CONTRACT NUMBER: C13-01-21

Tender for Prequalified Vendors for Interior Office Renovation at 330 Wentworth Avenue North

ADDENDUM 1

AD
607

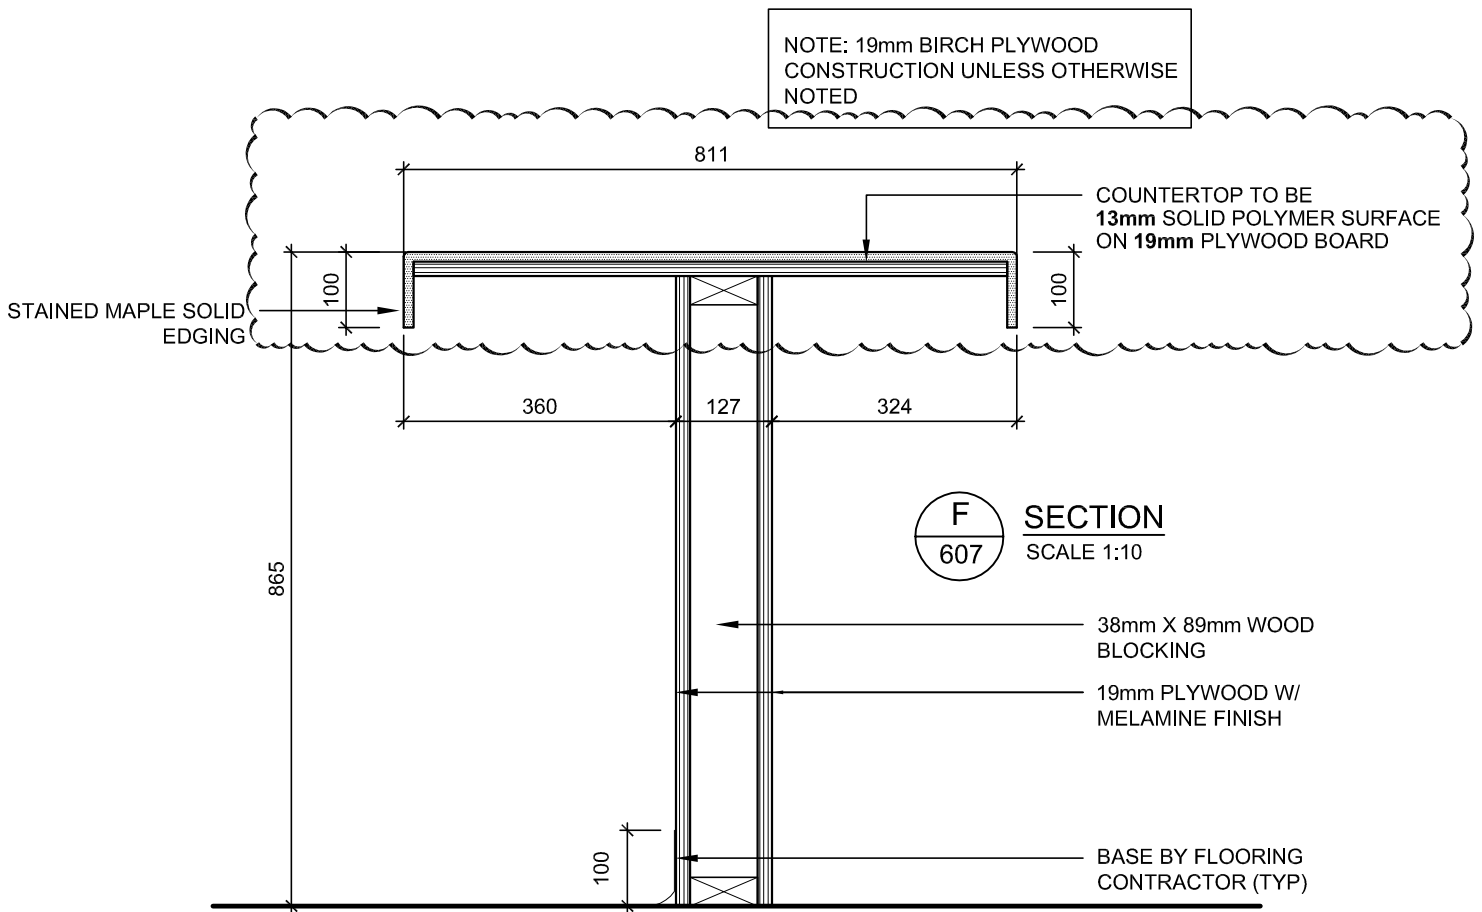
Item 1 Refer to attached Architectural Detail drawings AD607 and AD613 for the revision to the countertop material for millwork items MM15

3. Bidders are advised to delete AD607 and replace with AD607 as attached in this Addendum 1.
4. Bidders are advised to delete AD613 and replace with AD613 as attached in this Addendum 1.
